Access Compliance Report Public Rights-of-Way (RR Crossings)

Intersection ID: 10025310	Main Street: E_5TH_ST	Location: N/A
ADA ID: BAE03E0B646B	Overall Compliance: No	Severity Score: 0.0
Codes/Mitigation Info/Possible Solution		Field Measurements/Component Compliance

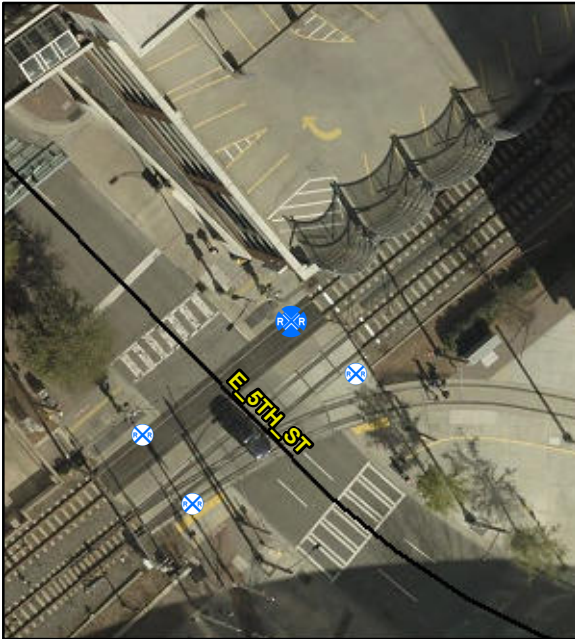
Compliance	Description	Data
Yes	DWS Provided?	Yes
Yes	DWS Contrast?	Yes
Yes	DWS Width (in)	Yes
Yes	DWS Length (in)	36.0
No	DWS Offset (in)	28.0
No	Pedestrian Gate?	No
N/A	DWS Outside Gate?	N/A
N/A	Rail Type?	LightRail
Yes	Flangeway Gap (in)	2.0
Yes	Sidewalk Width (in)	114.0

**Remove & Replace Detectable
Warning System. Provide Pedestrian
Gate.**
